SINSW Centre Of Excellence (Richmond)

Road Safety Audit

Detailed Design Stage

JN22024_Report01 Rev01 - TTW Richmond COE

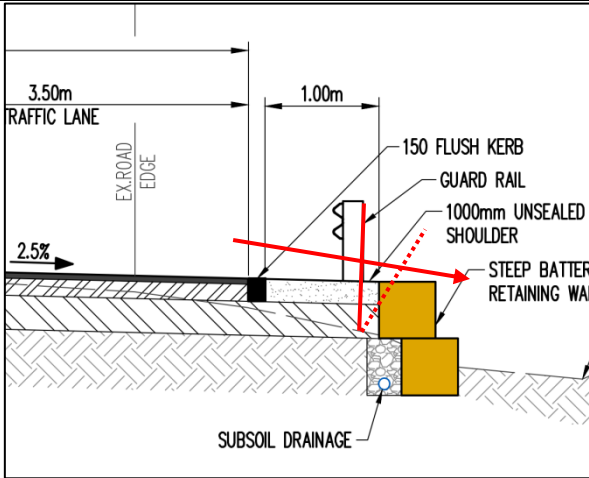
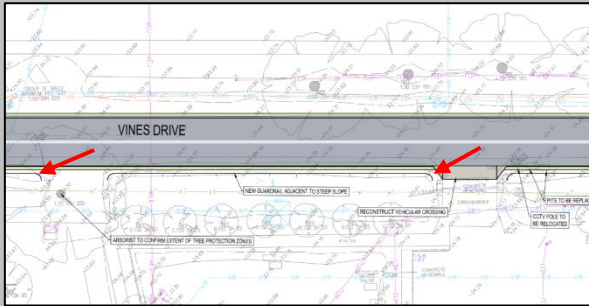
Item Location	Safety Hazard Finding	Frequency	Severity	Level Of Risk	Project Manager Response
1. Intersection Delineation Londonderry Road	<p>There is no delineation on the terminating leg of the T-intersection.</p> <p>There is a risk at night or during adverse weather that a motorist may not sight the intersection point and approach the intersection at high speed (accelerating after exiting the 40 zone) with insufficient time to decelerate to a stop before entering the through lane resulting in side impact collisions from through vehicles.</p> 	Improbable	Minor	Medium	Signage and line marking plan to be developed for this area, including retro-reflective pavement markers (RRPMs), T-intersection advance warning signage, and T-intersection terminating signage (<<< >>>).

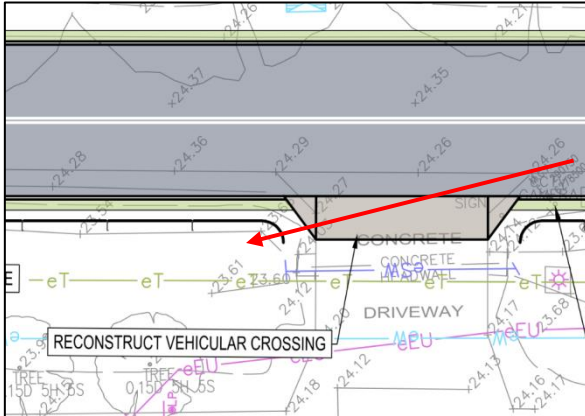
2. Drainage Londonderry Road	<p>The proposed widening works at the Londonderry Road intersection creates a road formation cut profile and no drainage infrastructure is proposed.</p> <p>There is a risk that water may pond into the through travel lanes of a 60 km/h zone resulting in aquaplaning incidents.</p> <p>There is a risk that ponding water may damage the pavement surface creating vehicle/motorcycle destabilisation incidents resulting in run-off-road or head-on collisions, particularly when negotiating a corner.</p> <p>There is a risk that water flows may erode the edge of the pavement creating a vertical drop that may</p>	Probable	Serious	Intolerable	<p>Existing blocked pipe to be replaced and improved as part of intersection works which should reduce ponding.</p> <p>A drainage channel to bring water off the roadway will also be considered in the detailed design.</p> <p>Pavement and/or kerb design to be reviewed to avoid erosion.</p>

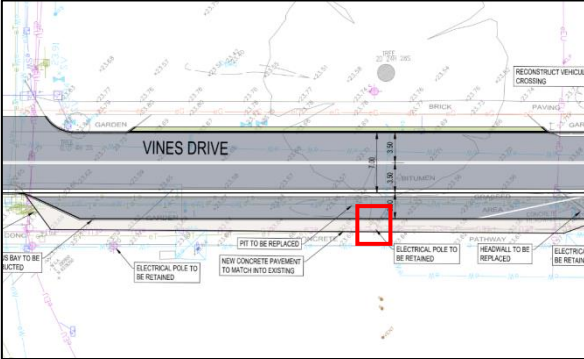
3. Overhanging Branches Extent of Works	<p>There are low and overhanging branches throughout the extent of works.</p> <p>There is a risk that a branch may fall on a vehicle or fall into the travel lane and be impacted by a vehicle resulting in injury to vehicle occupants.</p> <p>There is a risk that a vehicle may impact overhanging branches causing them to fall onto the vehicle or into the travel lane and be impacted by another vehicle resulting in injury to vehicle occupants.</p>	Improbable	Minor	Medium	<p>Height clearances and tree conditions under review with arborist, it is anticipated that pruning will be required to various trees.</p> <p>Some residual overhang of trees is expected as part of the urban design of the space and to retain tree canopy coverage of the area. Ongoing review and maintenance may be required by WSU.</p>

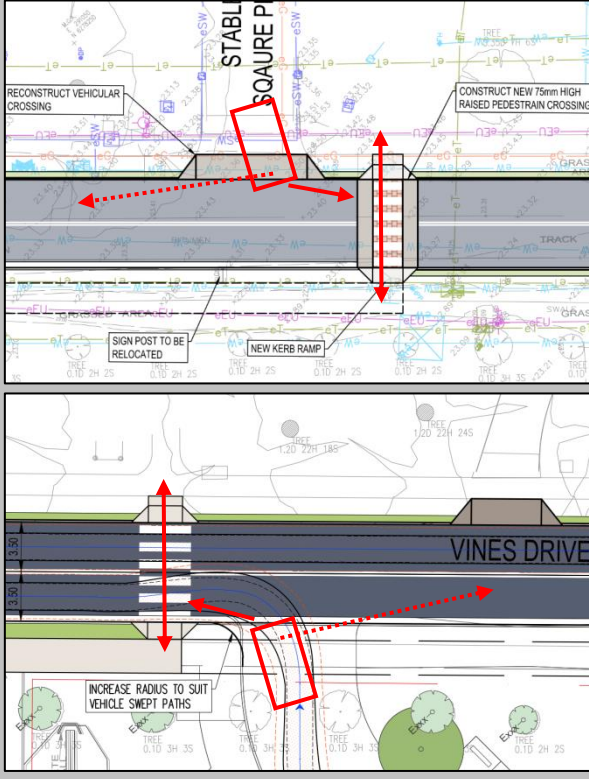
4. Barrier Post Support Extent of Works	<p>There is insufficient support provided behind the barrier post.</p> <p>There is a risk that an errant vehicle may not be contained by the barrier resulting in a vehicle reaching a hazard, snag/roll incidents and injury to occupants.</p>	Improbable	Serious	Medium	Road sections will be designed to provide the required support distance behind guard rails; design to manufacturer requirements once a barrier product is selected.

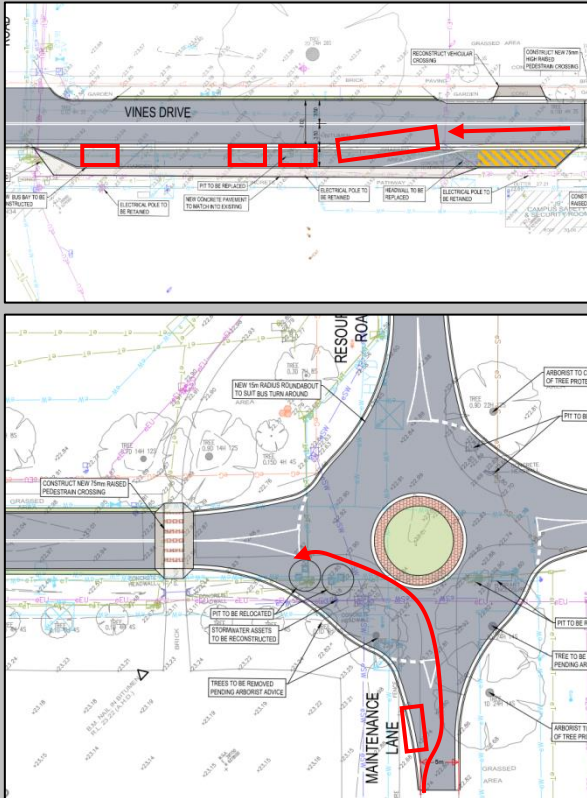
5. Barrier Terminals Extent of Works	<p>There are no barrier terminals provided.</p> <p>There is a risk that an errant vehicle may impact the exposed end of a barrier rail resulting in spearing of a barrier rail into a vehicle cabin and vehicle occupant.</p> 	Probable	Serious	Intolerable	Terminal treatments to be provided; consider replacing barriers with a suitable swale/runoff treatment where appropriate.
6. Barrier Extents Extent of Works	<p>It is unclear to the audit team if the barrier point of need is met, particularly where short breaks are provided in the barrier system.</p> <p>There is no hazard free zone provided at barrier end points.</p>	Occasional	Minor	Medium	Swale area to be reviewed to remove points of need and delete barrier where possible.

Item Location	Safety Hazard Finding	Frequency	Severity	Level Of Risk	Project Manager Response
	<p>There is a risk that an errant vehicle may impact a hazard behind a barrier end resulting in injury to vehicle occupants.</p> 				
<p>7. Large Rocks Extent of Works</p>	<p>There are large rocks adjacent to the travel lane throughout the extent of works.</p> <p>There is a risk that an errant vehicle may impact a non-frangible hazard resulting in vehicle damage or injury to vehicle occupants.</p> 	Occasional	Minor	Medium	To be reviewed with WSU and deleted where possible.
<p>8. Intersection Controls Extent of Works</p>	<p>The existing line marking and signage at intersection points is faded/damaged, particularly Horticulture Road.</p> <p>It is unclear to the audit team on the requirement to replace an intersection control with a vehicle crossing, tying into an existing road and leaving part of the intersection control signage and line marking in place.</p>	Probable	Minor	High	All new signs and line marking to new work.

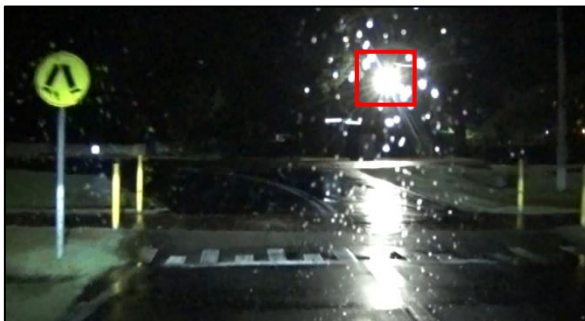
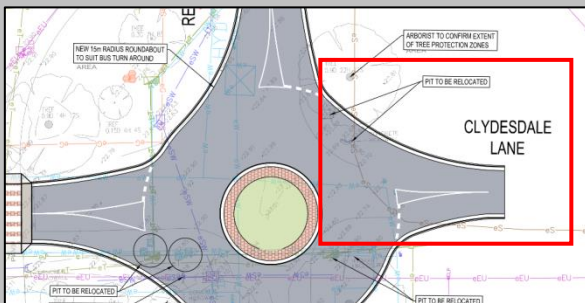
Item Location	Safety Hazard Finding	Frequency	Severity	Level Of Risk	Project Manager Response
	<p>Incomplete arrangements may increase driver confusion.</p> <p>There is a risk at night or during adverse weather that a motorist may not sight the intersection point and approach the intersection with insufficient time to decelerate to a stop before entering the through lane resulting in side impact collisions from through vehicles.</p> 				
9. Ponding water Extent of works	<p>On site it was observed that pavement water was ponding against raised pedestrian crossings, against the raised grassed verge, at blocked drains and at pavement depressions throughout the site.</p> <p>Specific locations include Vines Drive at Yarramundi Road and side road opposite Yarramundi Road.</p>	Occasional	Minor	Medium	Stormwater strategy to be finalised in detailed design.

Item Location	Safety Hazard Finding	Frequency	Severity	Level Of Risk	Project Manager Response
	<p>There is a risk that ponding water may damage the pavement surface creating vehicle/motorcycle destabilisation incidents resulting in run-off-road or head-on collisions.</p> <p>There is a risk that water flows may erode the edge of the pavement resulting in vehicle snag/roll incidents.</p> 				
10. Existing Pole Bus Zone	<p>There is an existing pole to be retained at the back of kerb in the proposed bus zone.</p> <p>There is a risk that a bus entering the bay may impact the pole, resulting in vehicle damage, or that the falling pole may impact a waiting/passing pedestrian.</p>	Occasional	Limited	Low	Pole to be relocated if possible (TBC by RCC/WSU).

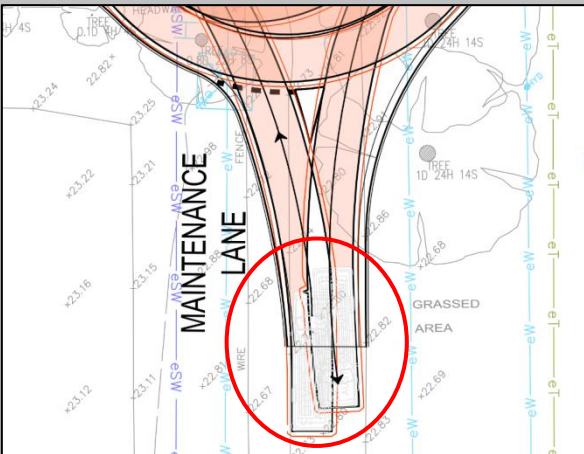
11. Pedestrian Crossing Proximity Extent of Works	<p>There are pedestrian crossings proposed adjacent to intersection points throughout the extent of works.</p> <p>There is a risk that a motorist exiting the intersection may focus on vehicles approaching from the right and not sight a pedestrian entering the crossing from the left resulting in pedestrian-vehicle collisions.</p> <p>This risk is increased given an inconsistent application of pedestrian crossing infrastructure such as approach</p>	Occasional	Serious	High	Distance from intersections/driveways to be increased where possible, or pedestrian crossings to be deleted if demand is low to avoid confusion.

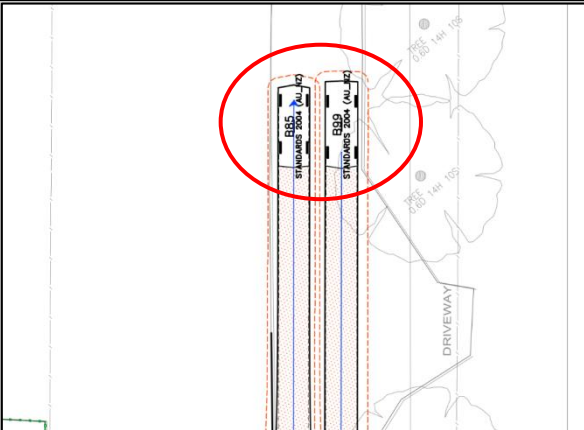
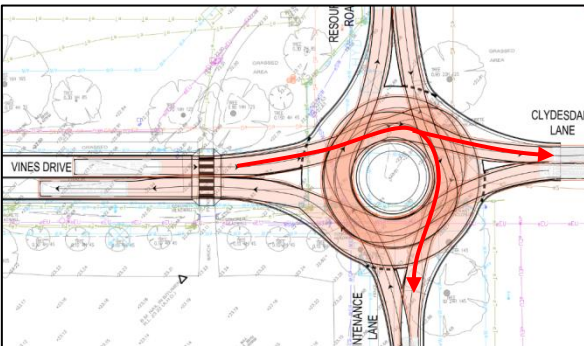
Item Location	Safety Hazard Finding	Frequency	Severity	Level Of Risk	Project Manager Response
	<p>signage from all directions, line marking, and raised thresholds.</p> <p>This risk is increased where vehicle and pedestrian volumes are increasing.</p> 				
12. Pedestrian Crossing Sight Extent of Works	<p>There are multiple pedestrian crossings, both existing and proposed, without line marking, signage and lighting.</p> <p>The legal requirement for a motorist to give-way at a pedestrian crossing that is not line marked and only sign posted in one direction is not clear.</p>	Improbable	Serious	Medium	Consistency of crossing treatments is under review. Any crossings in the final design will have line marking and signage in both directions.

Item Location	Safety Hazard Finding	Frequency	Severity	Level Of Risk	Project Manager Response
	<p>An inconsistent approach to pedestrian facilities may increase driver confusion/frustration, and decrease pedestrian compliance.</p> <p>There is a risk that an approaching motorist may not anticipate a pedestrian stepping out into the travel lane resulting in pedestrian-vehicle collisions.</p>

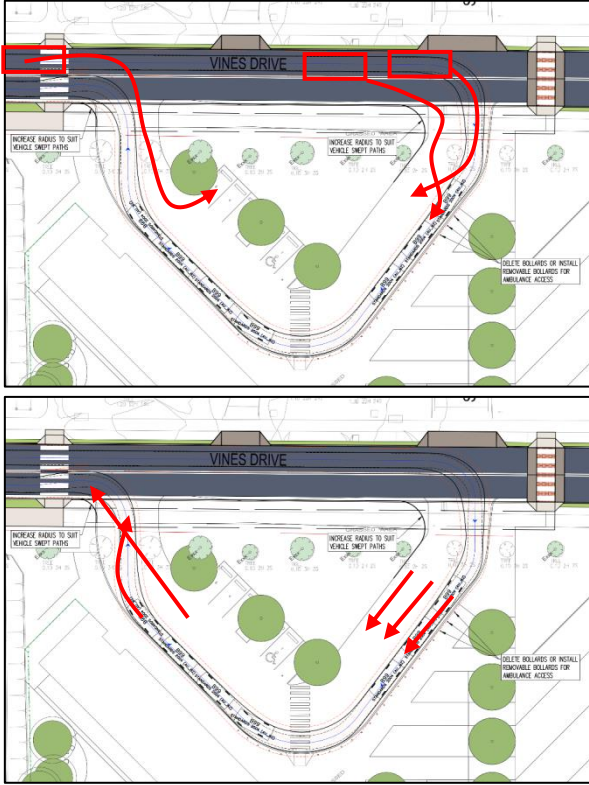
Item Location	Safety Hazard Finding	Frequency	Severity	Level Of Risk	Project Manager Response
	<p>There is a risk that a motorist may not sight approaching intersections, configurations, hazards due to parked vehicles resulting in run-off-road, side-impact or side swipe collisions.</p> 				
14. Lighting Roundabout	<p>There is no proposed lighting at the proposed roundabout. At the existing curve there is an existing flood light on a pole set back in a paddock that is directed into an eastbound driver's eyes.</p> <p>There is a risk at night or during adverse weather that a motorist may not sight the intersection configuration resulting in impacts with roadside</p>	Probable	Minor	High	Lighting anticipated to be provided at roundabout and pedestrian crossing locations, to be reviewed and confirmed by lighting/electrical consultant.

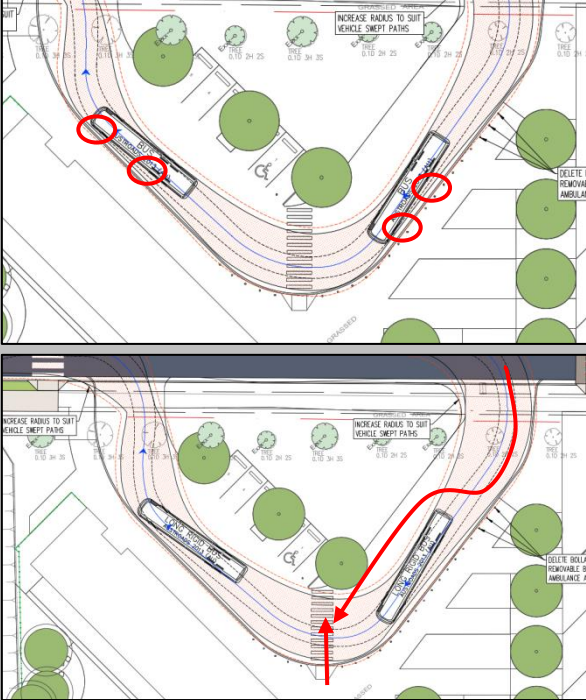
Item Location	Safety Hazard Finding	Frequency	Severity	Level Of Risk	Project Manager Response
	<p>infrastructure, pedestrians, or other vehicles circulating the roundabout.</p> 				
<p>15. Survey Clydesdale Lane</p>	<p>There is no survey provided at the Clydesdale Lane leg on the roundabout. The proposed alignment of the leg appears to be offset from Vines Drive and from the existing Clydesdale Lane. The proposed width does not match the existing width.</p> <p>There is a risk that staggered alignments and incomplete works may resulting in run-off-road incidents.</p> 	Probable	Limited	Medium	Further survey is being undertaken, final design will suit surveyed configuration.
<p>16. Infrastructure Clydesdale Lane</p>	<p>There is existing infrastructure at the intersection of Clydesdale Lane including a brick hydrant enclosure, stay pole, and CCTV pole.</p> <p>There is a risk that a pedestrian or motorist may impact hazards in pedestrian paths, clear zones, or in the travel lane.</p>	Frequent	Minor	Intolerable	Existing infrastructure to be relocated as part of roundabout works.

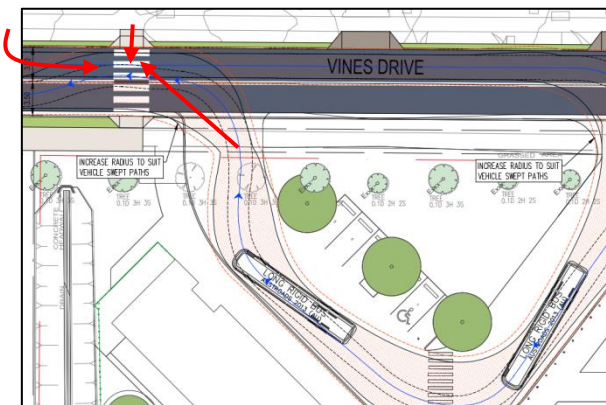
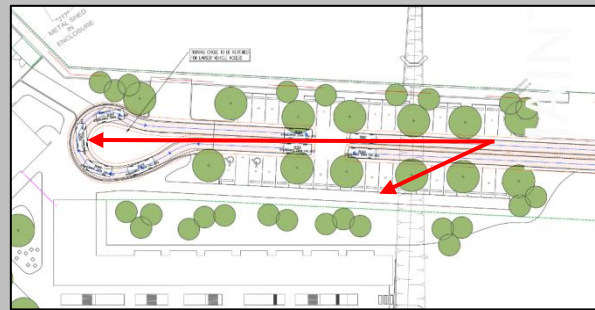
17. Width Maintenance Lane	<p>The turning path plan for the roundabout shows 2-way traffic colliding at the Maintenance Lane splitter island, however the Maintenance Lane Carpark turning path plan indicates there is sufficient width for 2-way traffic.</p> <p>There is a risk that the existing width on Maintenance Lane may not be sufficient for 2-way traffic resulting in side-swipe or head-on collisions with oncoming traffic, run-off-road incidents, or collisions with roadside infrastructure, hazards or pedestrians.</p> 	Frequent	Minor	Intolerable	<p>Treatment for two-way traffic along Maintenance Lane is under review. Traffic movements are generally expected to be one-way (e.g. arrivals in the morning, departures in the afternoon) so limited two-way traffic is expected. A priority system can be designed, and will ensure sufficient space for vehicles off the circulating area of the roundabout.</p>

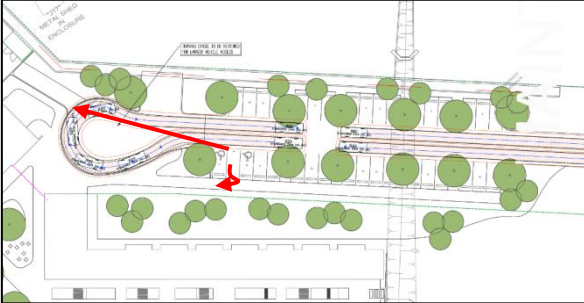
Item Location	Safety Hazard Finding	Frequency	Severity	Level Of Risk	Project Manager Response
18. Vehicle Restrictions Roundabout		Occasional	Minor	Medium	Vehicle restriction signage will be reviewed and considered with the university, however large vehicles may be required to service the surrounding facilities. No Through Road signage may be suitable.
	<p>There are roads with no through route, turn around areas, or termination warnings provided at decision points.</p> <p>There are no vehicle restrictions provided where large vehicle turning paths are not provided to confirm access is achievable.</p> <p>There is a risk that a vehicle may enter a restricted road and undertake unsafe movements such as long reversing, U-turns, multiple point turns, or mounting pedestrian areas to exit out of the road resulting in pedestrian-vehicle collisions, collisions with other vehicles or roadside infrastructure.</p>
